## **Planning, Land Use and Mobility Committee Case Report**

Case Nos: DIR-2021-6258-DRB-SPP-MSP  
ENV -2021 6259 -CE

Site Location: 4337 N. Divina St., Woodland Hills, 91364

Project: The applicant is proposing to construct a new 2 story SFD, with attached two car garage on a down slope vacant lot fronting on an unpaved street in the outer Mulholland corridor.

WEST ELEVATION

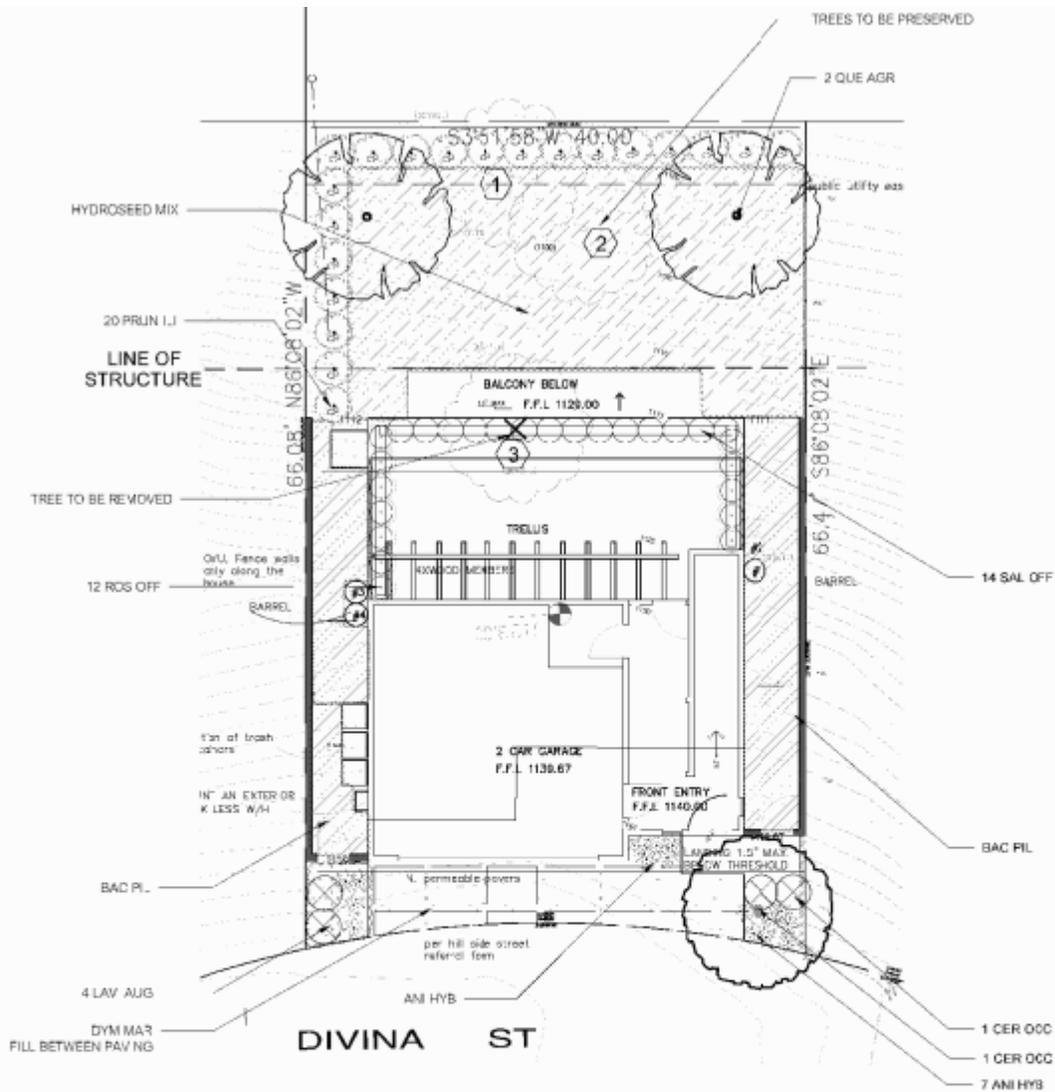
5. The stone on the East Elevation/front facade shall wrap the North and South elevations equally to the first stucco control joint. The overhang shall extend approximately 1 foot beyond the stone. Applicant shall submit and present alternate revised drawings to the Mulholland Design Review Board review. (Note: Revised elevations have been submitted to the PLUM committee on 4/22/22 reflecting this revision to the building design and are part of the Final PLUM Case Report).
